EXHIBIT A
(Kleinfelder Report)

March 11, 2022
Project No. 20224083.001A

**SUBJECT: Geotechnical and Materials Engineering Evaluation
PG&E Claim File No. B19446484
2845 Magnolia Street
Oakland, California**

Photo 4. Driveway slab typical shrinkage network cracking.

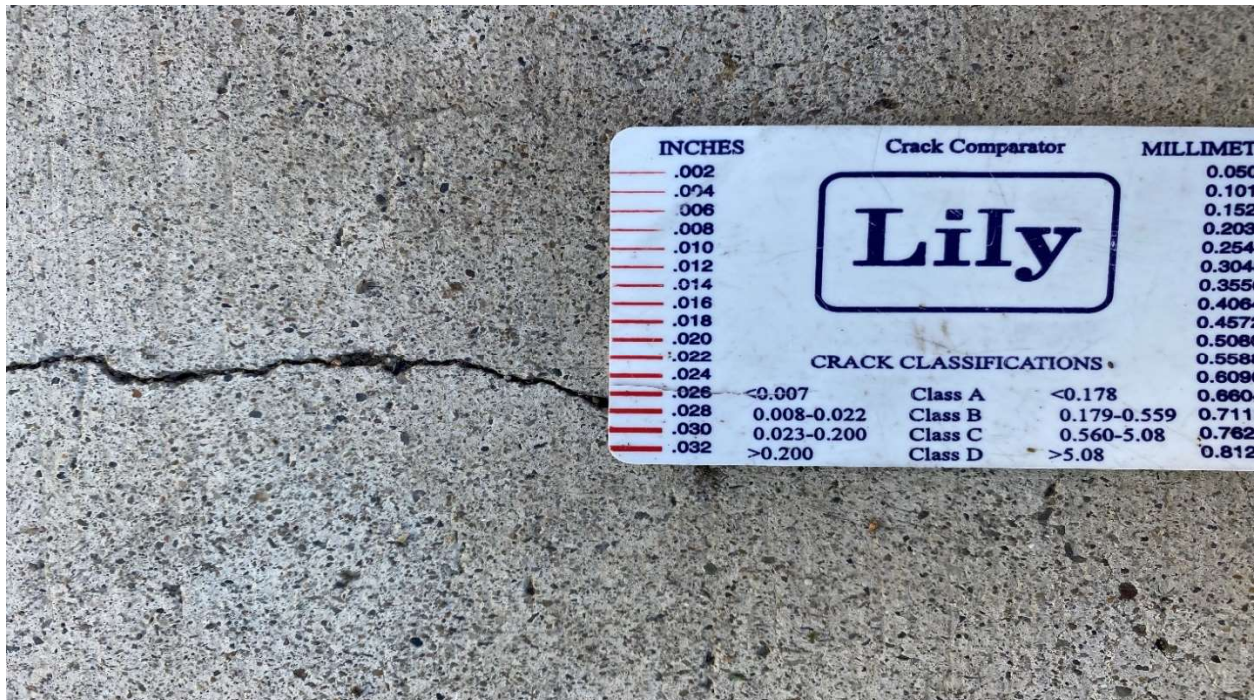
- Driveway crack widths commonly range in size from "hairline" to 0.028" (see Photos 4 and 5 above).
- Driveway cracks appear to develop as shallow or near-surface features; however, some cracks appear to develop as sectional "through" cracks.

Photo 14. Radiogram view of driveway slab showing interpreted concrete section, presence of welded wire fabric reinforcement (3¾" to 4¾" depth), and bottom of concrete slab (5" to 5½" depth).

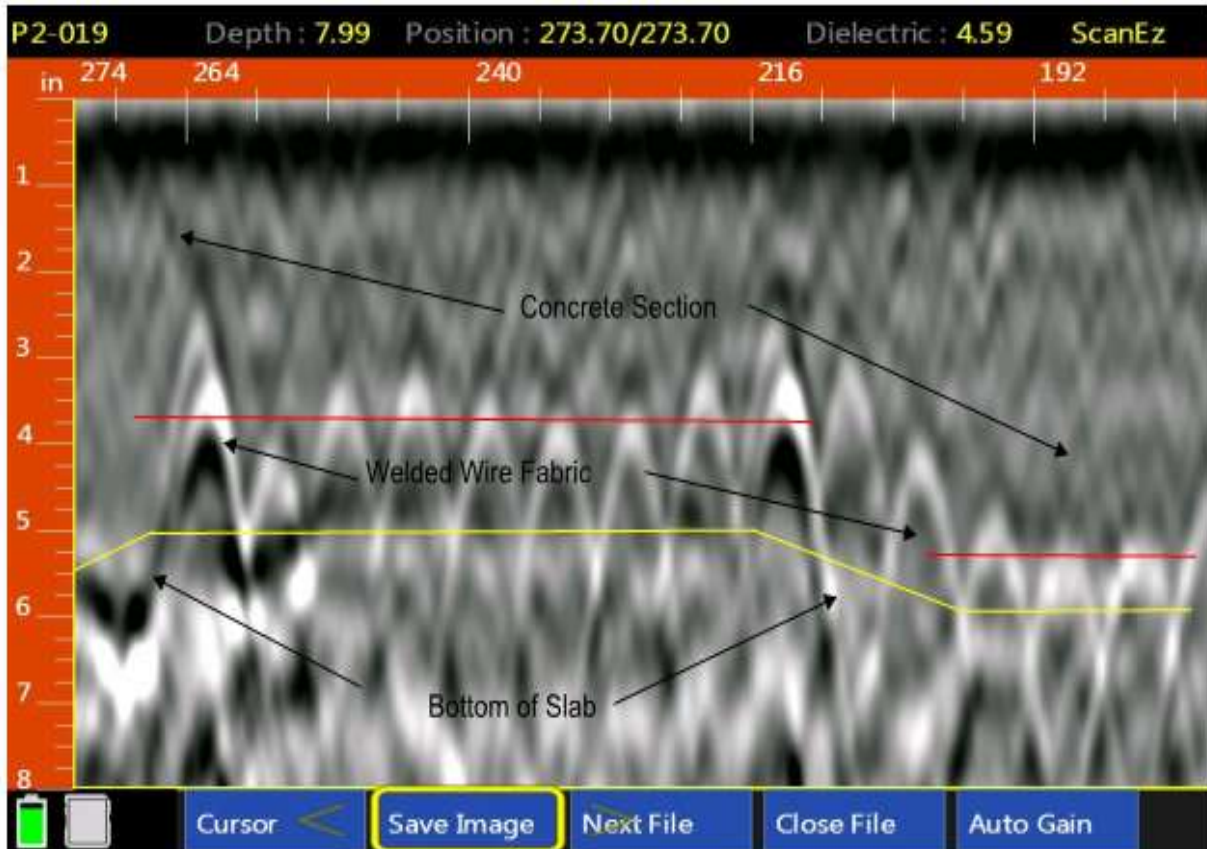
Review of the GPR radiograms suggests variable concrete slab thickness in the driveway slab area. Based upon interpretation of the GPR radiograms, the slab area appears as a nominal 5-inch thick slab with indications of localized thinner sections. The interpreted reinforcing (WWF) appears to be positioned variably in depth throughout the slab thickness and does not appear to be centrally located within the slab thickness and in some instances appears to be positioned in near contact with subgrade soil. Conventional reinforcing detailing requires construction reinforcement of this type to be positioned centrally within the concrete slab section.

Typical radiogram images of the driveway and garage floor slab areas are provided below in Photos 14 and 15. Approximate locations from where these images were taken are shown on the schematic driveway plan, Figure 1.

Photo 15. Radiogram view of garage floor slab showing interpreted concrete section thickness (roughly 4½" thickness). The radiograms gathered for the garage slab showed no evidence of steel reinforcement.

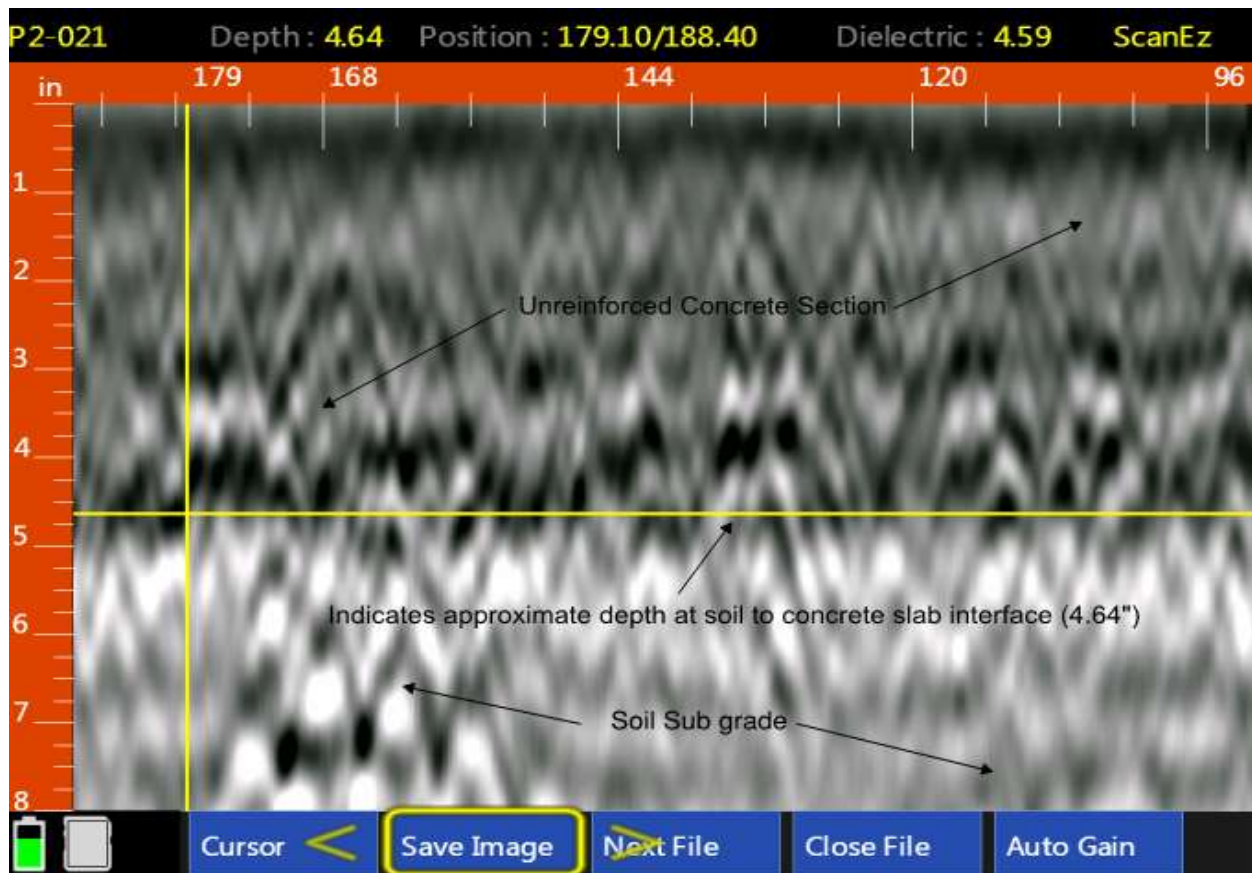
- In Kleinfelder's opinion, the observed cracks in the garage floor are not related in any way to the activities conducted by PG&E in 2016.
 - We found no evidence of steel reinforcement in the garage floor slab (see discussion of GPR soundings below).

Figure 1 – Schematic Driveway Plan

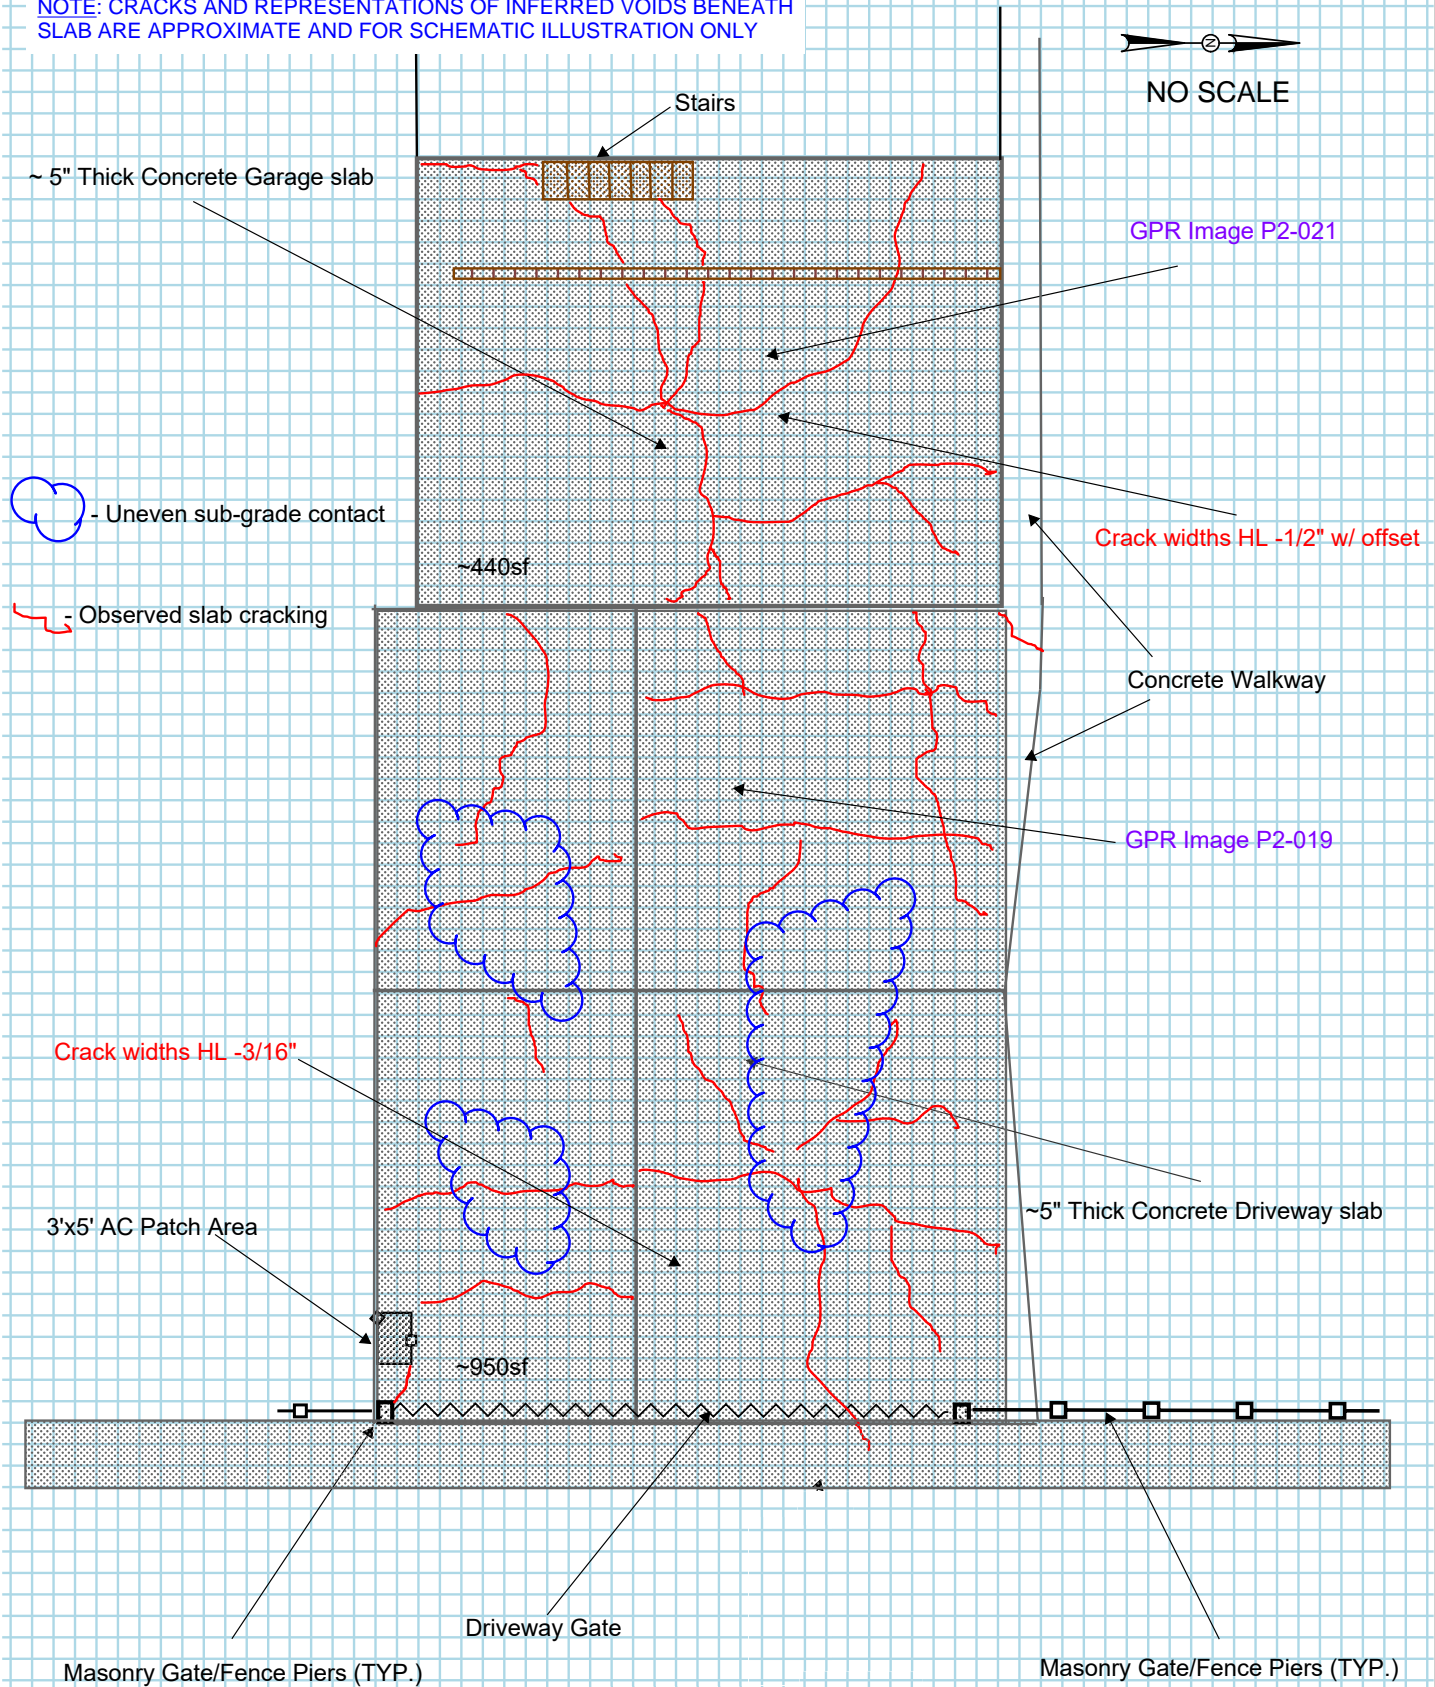
Manual impact sounding utilizing a percussion wheel identified apparent acoustical responses consistent with the presence of local soil interface subsidence. Approximate locations of apparent uneven slab-subgrade contact are shown on Figure 1. Localized GPR surveys and interpretations of radiographic images further suggests there to be a potentially narrow interface (void) located variably surrounding the areas of driveway slab construction.
